DOCKETS 50-266 AND 50-301
TECHNICAL SPECIFICATIONS CHANGE REQUEST 168
MODIFICATION TO TS 15.3.3, "EMERGENCY CORE COOLING SYSTEM,
AUXILIARY COOLING SYSTEMS, AIR RECIRCULATION FAN COOLERS, AND
CONTAINMENT SPRAY;" 15.3.4, "STEAM AND POWER CONVERSION SYSTEM;"
AND 15.3.7, "AUXILIARY ELECTRICAL SYSTEMS"
POINT BEACH NUCLEAR PLANTS, UNITS 1 AND 2

TECHNICAL SPECIFICATION CHANGE REQUEST 168
SAFETY EVALUATION

TECHNICAL SPECIFICATION CHANGE REQUEST 168
"NO SIGNIFICANT HAZARDS CONSIDERATION"

ELECTRICAL DISTRIBUTION - INCLUDING DC

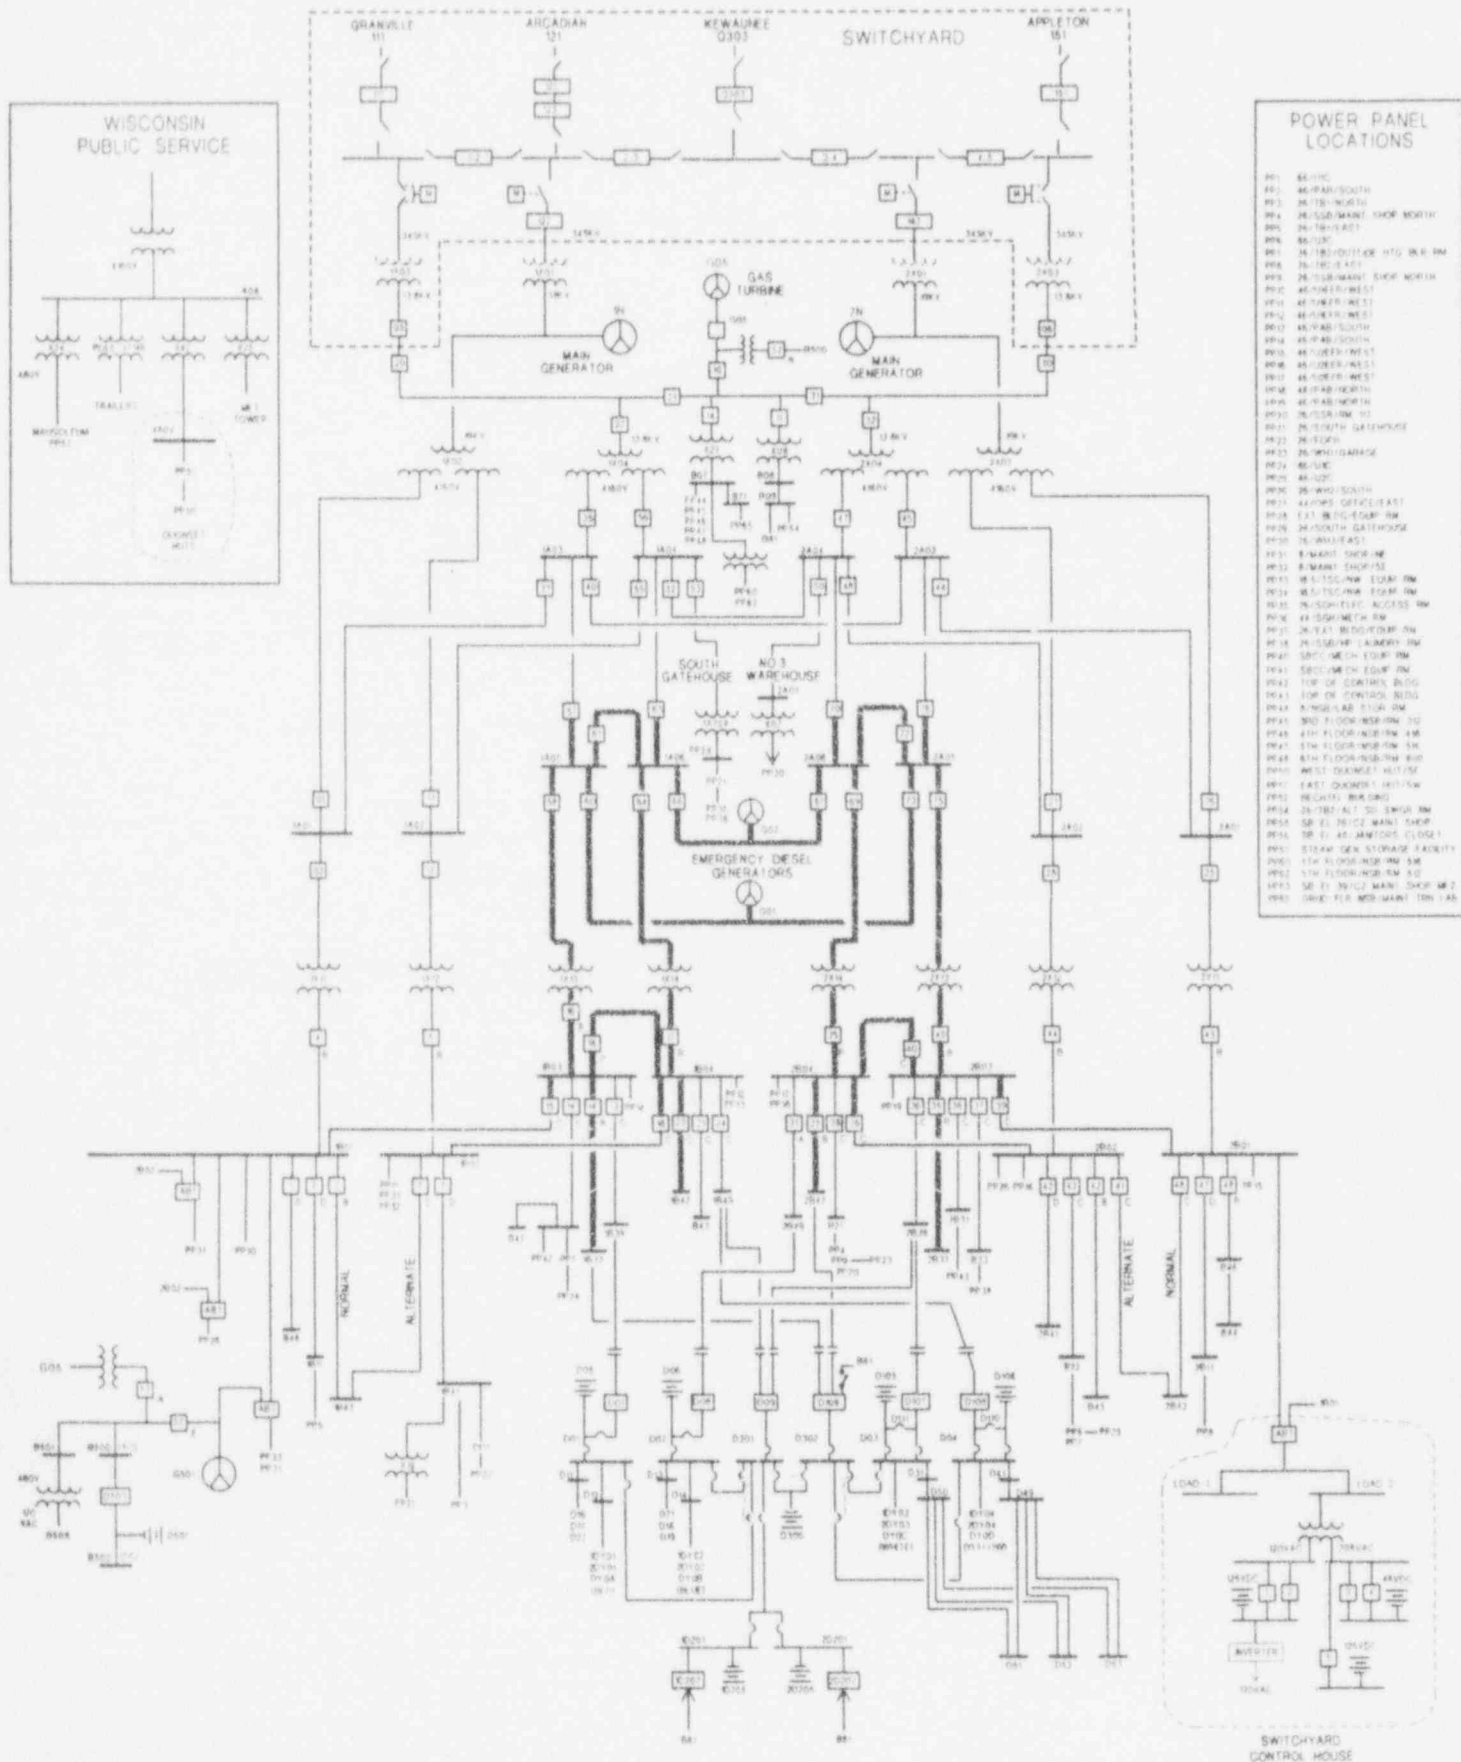
The attached figure titled "ELECTRICAL DISTRIBUTION - INCLUDING DC" shows the electrical distribution system for PBNP. The main sources of power at PBNP are the two main unit generators rated at 622,388 KVA at a power factor of 0.9. Additionally, at the start of the connection there will be two General Motors Corporation, Electro-Motive Division, Model 999-20 diesel engine-generator units, each rated at 2,850 kw continuous, 0.8 power factor, 900 rpm, 4,160 volts, 3-phase, 60 cycle. There will be three of these units available at the end of the connection process during the 1994 Unit 2 refueling outage.

PHASE 3A

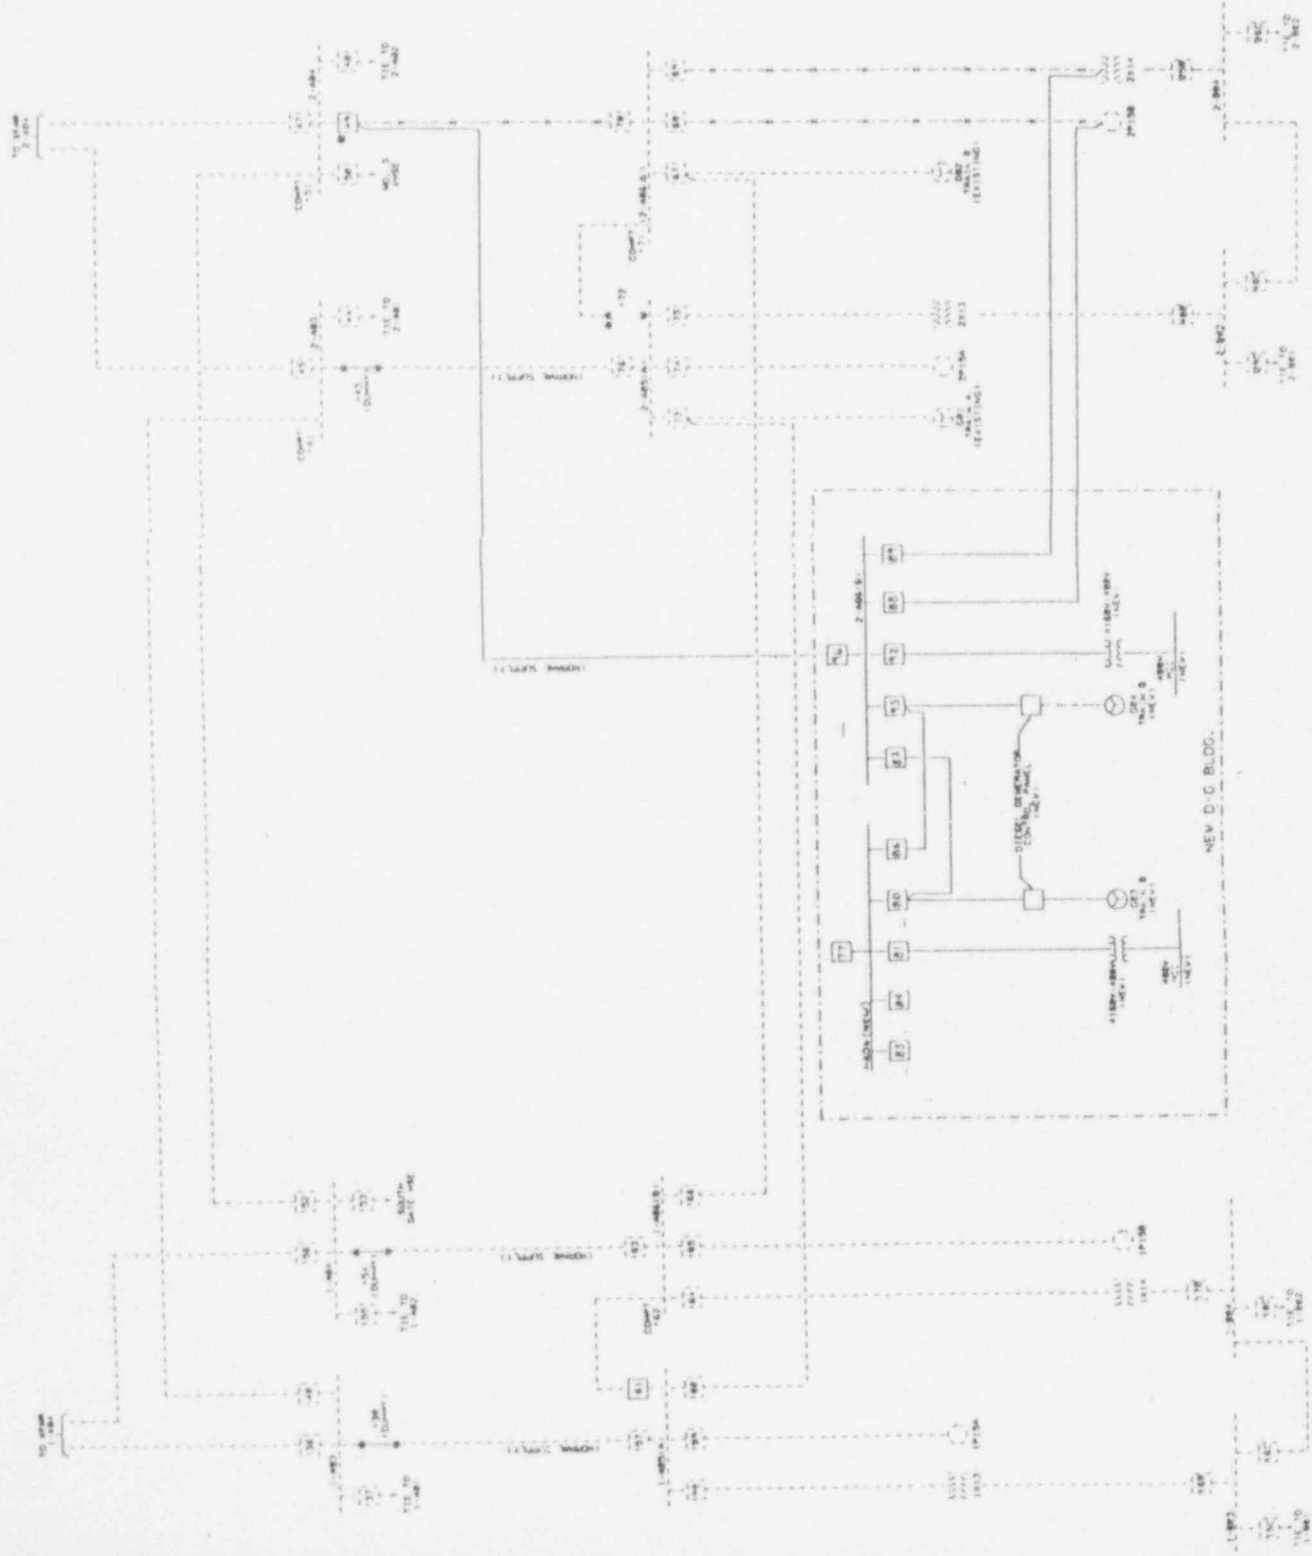
The connection of one of the new emergency diesel generators during the Unit 2 refueling outage will require that the Train B safeguards buses in Unit 2 be reconfigured (see the attached figure titled PHASE 3A). The 4160 Volt supply bus for Unit 2 Train B (2A04) and the 4160 Volt safeguards bus for Unit 2 Train B (2A06) will be out-of-service/de-energized, during the reconfiguration, to support the connection process. Power will be supplied to the Unit 2 Train B 480 Volt safeguards bus (B04) by a tie-breaker from the Unit 2 Train A 480 Volt safeguards bus (B03). Currently, options for supplying power to the Unit 2 Train B 480 Volt non-safeguards bus (B02) during the period that the non-safeguards 4160 Volt supply bus, Unit 2 A04, is out-of-service are being evaluated.

The major steps of the connection process include changing the power source of the Unit 2 Train B 480 Volt safeguards bus (2B04) from the existing Unit 2 Train B 4160 Volt safeguards bus (2A06) to the new 2A06, installation of a new supply breaker from the Unit 2 Train B 4160 Volt supply bus (2A04) to the new 2A06 and connection of 2A04 to the new 2A06. The final step will be to establish operability of the new EDG G-04 as a standby emergency power supply for the new 2A06.
